Subject: **PALO VERDE SOLAR I, LLC'S PETITION FOR AMENDMENT  
BLYTHE SOLAR POWER PROJECT  
DOCKET NO. (09-AFC-6C)**

# BLYTHE SOLAR POWER PROJECT

**AMENDMENT**  
**(09-AFC-6C)**

## **FIGURE 2-1**

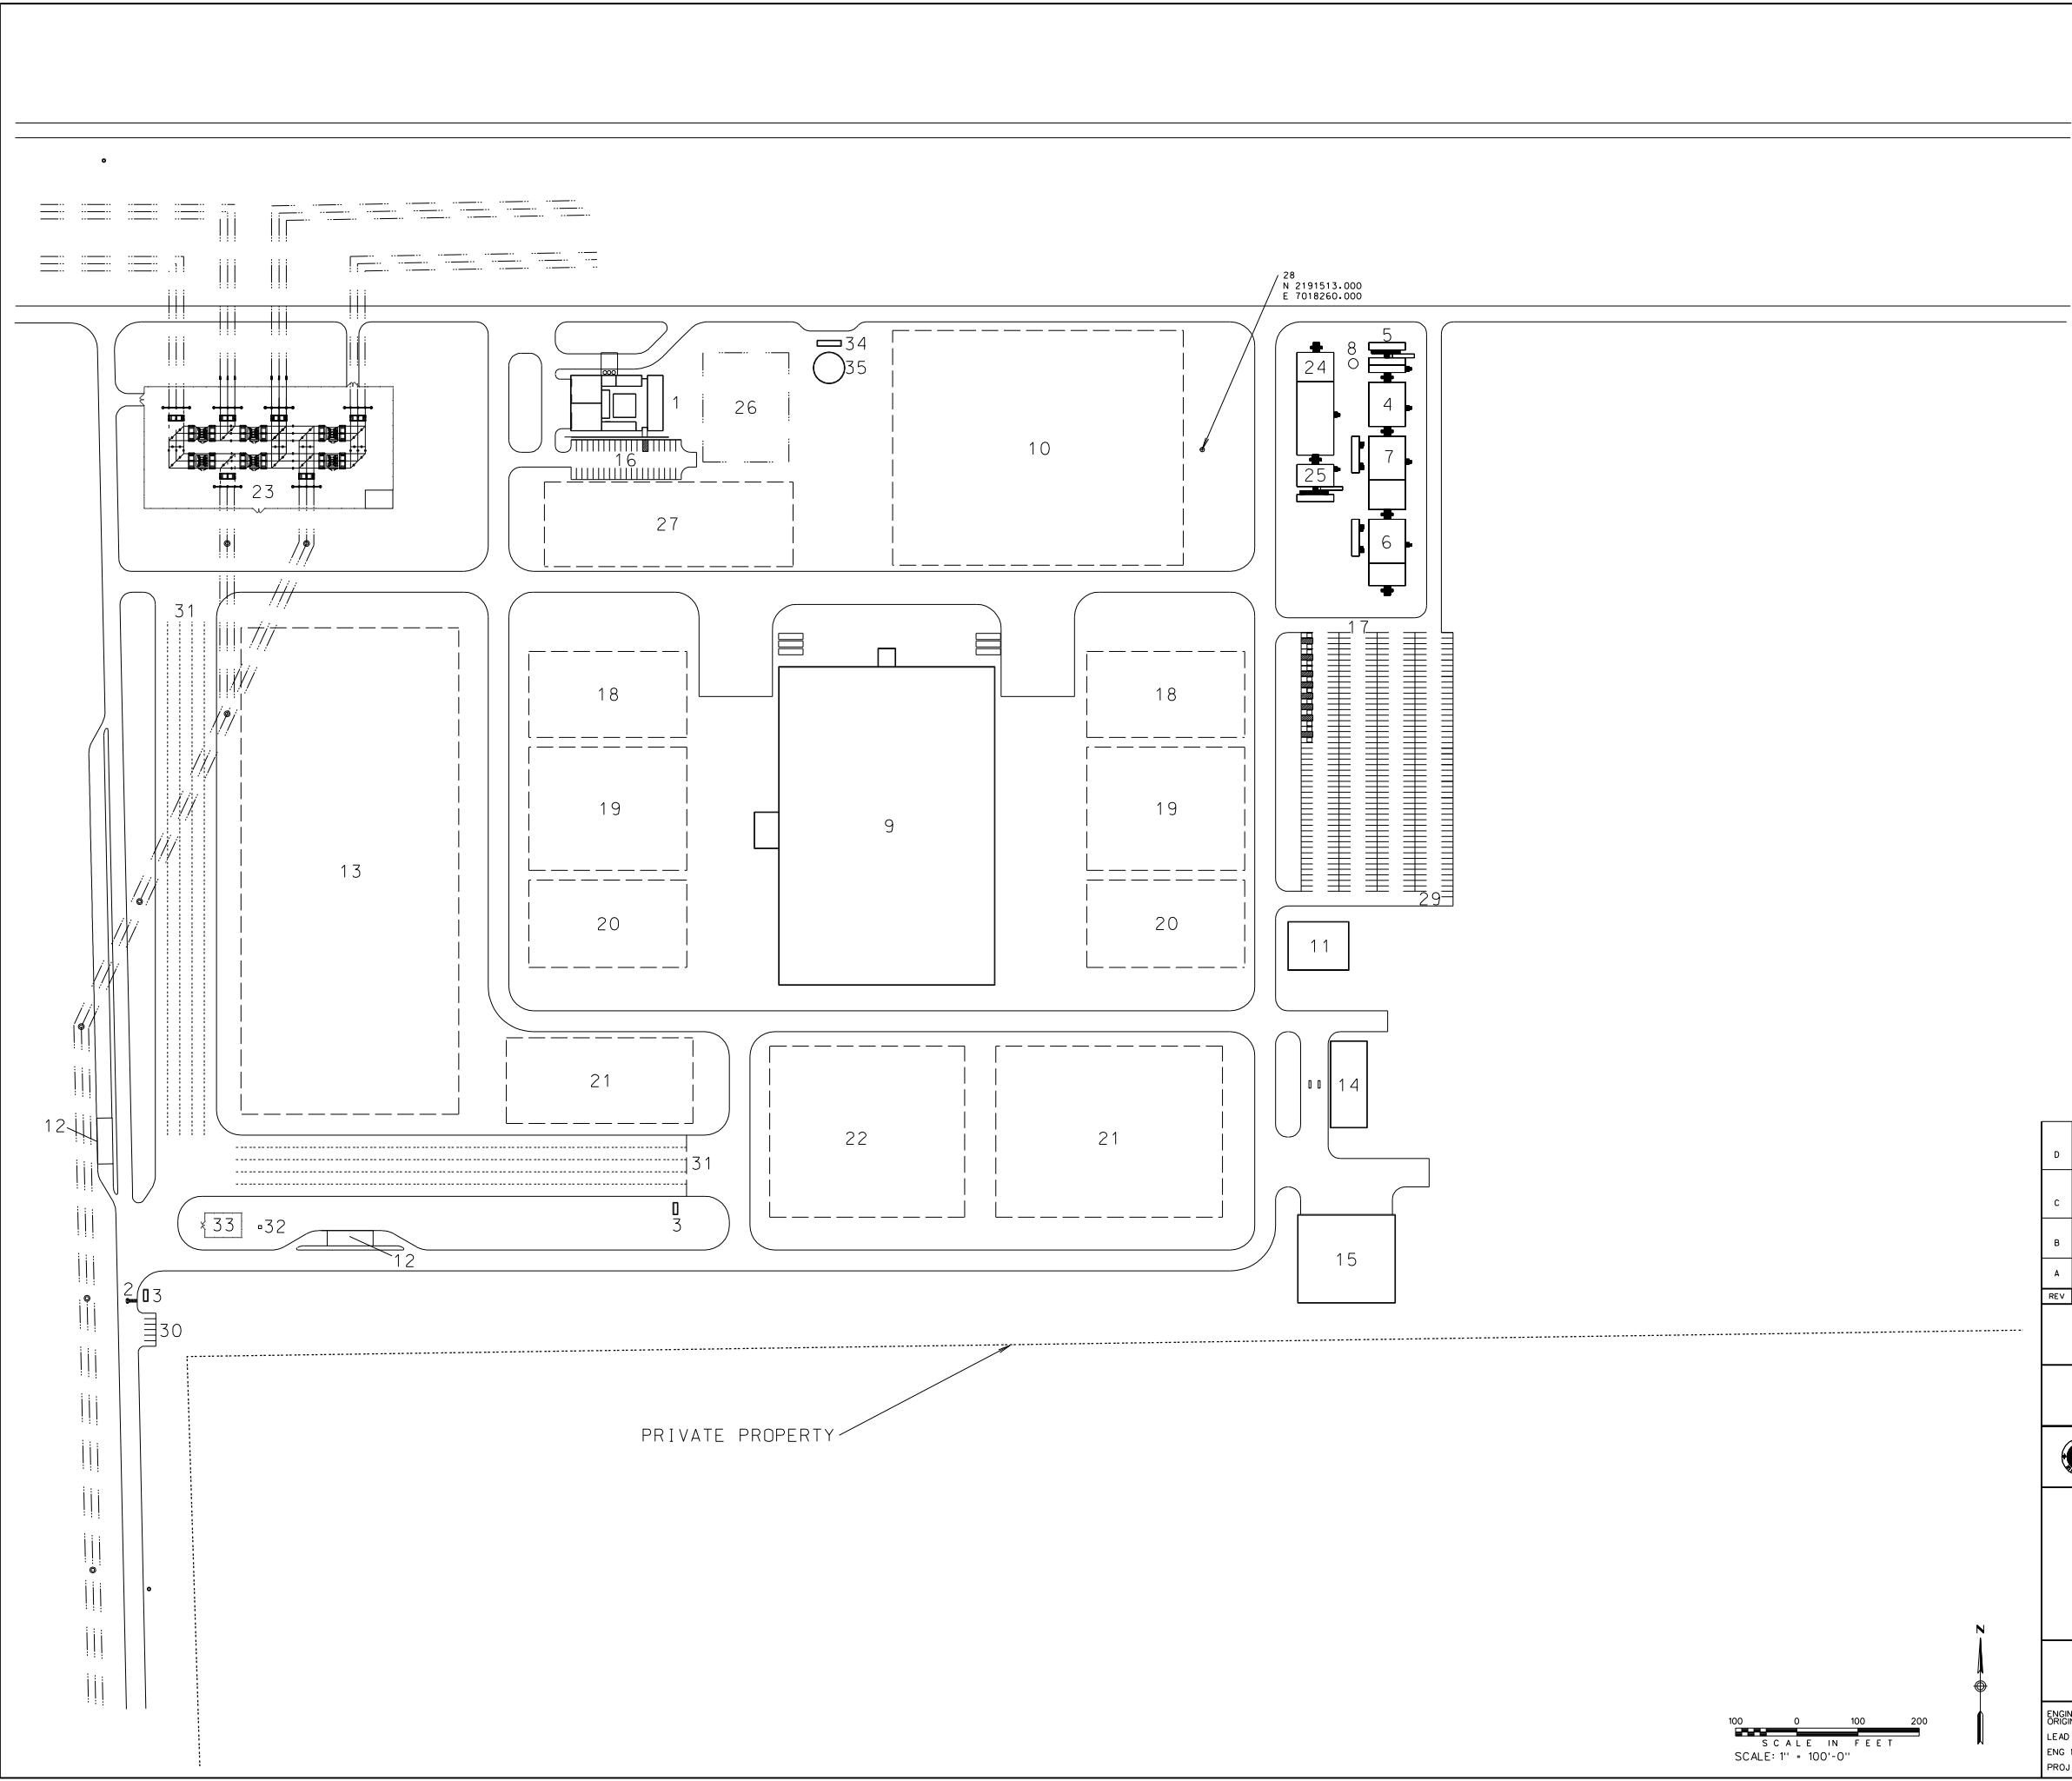
As discussed in Section 1 of this Petition, the facilities within the Shared Facilities Area have been rearranged to accommodate final design changes. All of the modifications will take place within the original location of the Shared Facilities Area as analyzed in the Staff Assessments and Final Decision. Since the Shared Facilities Area is within the project footprint (near the center) as described in the Final Decision, there will be no additional ground disturbance to accommodate the following modifications. The Plot Plan of the Shared Facilities Area is shown on **Figure 2-1**.

The switchyard for the BSPP has been relocated from its original central location to the northwest corner of the Shared Facilities Area. This relocation will result in elimination of four transmission poles.

To accommodate the needs of the Shared Facilities Area, it was determined that a 200,000 gallon fire water storage tank and associated electric fire water pump were necessary. The need was discovered during preparation of the Fire Risk Assessment for CEC and Chief Building Official compliance approval, which included coordination with Riverside County Fire Department. While the conceptual design of the fire protection system for the Shared Facilities was not explicitly described in the AFC, the original plan was for an extension of the fire water loop from Unit 1 to the Shared Facilities.

The Fuel Depot and Maintenance Building has been relocated to the southeast within the Shared Facilities Area.

The Concrete Batch Plant has been located approximately 950 feet west and 227 feet north of its original location. This relocation reduces the amount of paved surface necessary to provide access to the Plant.

The Assembly Hall has height has increased from 36 feet to 46 feet.

The Construction Trailers and associated Parking have been moved east of the original locations.

## **FIGURE 2-2**

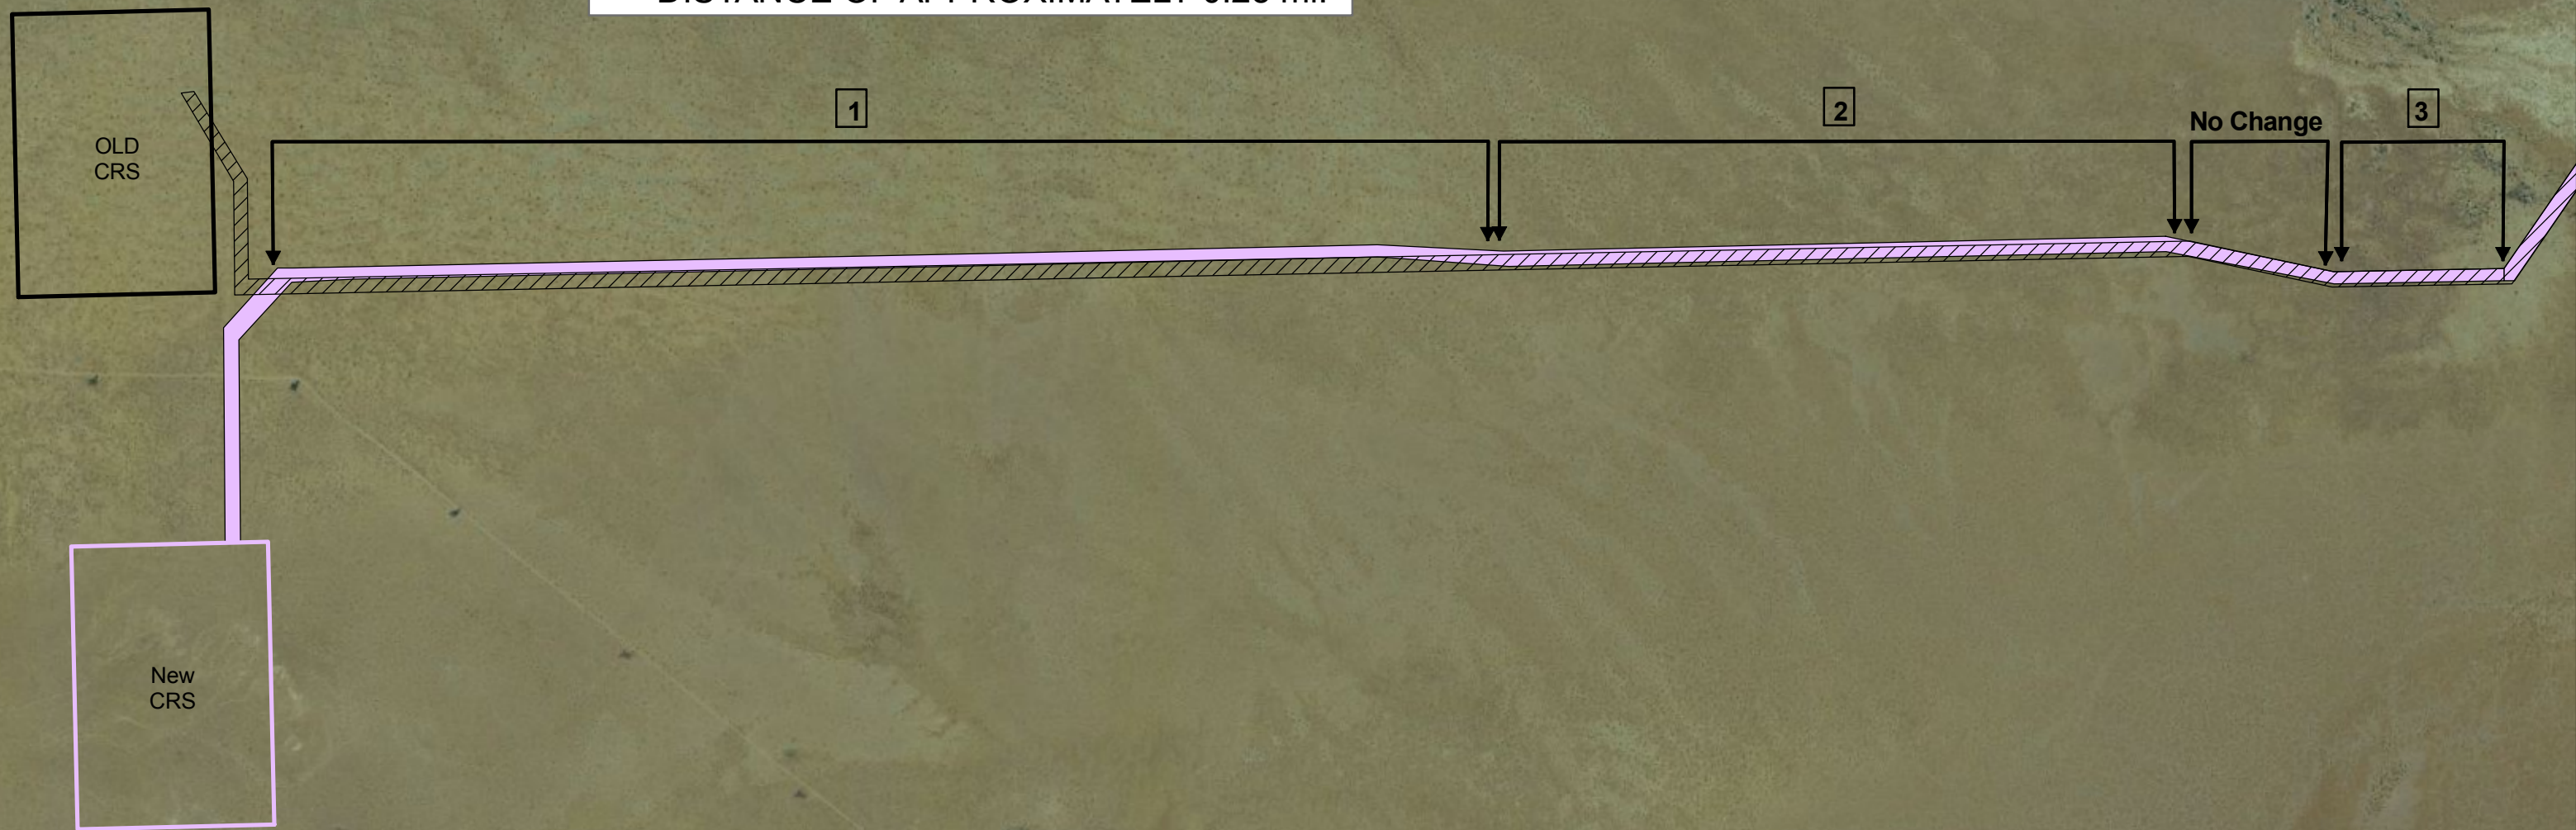
As discussed above, the last half mile of the Generation Tie-Line Route had been modified to terminate at the new alternative locations of the CRSS. Since the CPUC has not formally approved either alternative, in order to accommodate the BSPP Project Schedule it is necessary for PVSI to request both route reconfigurations be approved by the CEC even though only one will be constructed. Both routes involve only the last one-half mile of the Generation Tie-Line with an increase of approximately 700 feet to the end of the Generation Tie-Line. However, since the BSPP switchyard has been relocated to the Shared Facilities Area, the total length of the new Generation Tie-Line will be approximately 2900 feet shorter than the length contained in the Final Decision.

The Right-Of-Way width for approximately 1-3/4 miles of the Generation Tie-Line has also been decreased by 25 feet and shifted north approximately 70 feet to accommodate the Desert Southwest Transmission Project.

Additionally the re-route requires construction of an additional overcrossing of the existing 230 kV Blythe I Transmission Line. The re-route and overcrossing add one additional tubular steel transmission pole. The new Generation Tie-Line Routes are shown on **Figure 2-2**.

- 1 ROW REDUCED FROM 120 ft to 95 ft AND SHIFTED 70 ft NORTH A DISTANCE OF APPROXIMATELY 1.75 mi.
- 2 ROW SHIFTED 15 ft NORTH A DISTANCE OF APPROXIMATELY 1.0 mi. NO CHANGE TO ROW WIDTH.
- 3 ROW REDUCED FROM 120 ft to 95ft A DISTANCE OF APPROXIMATELY 0.25 mi.
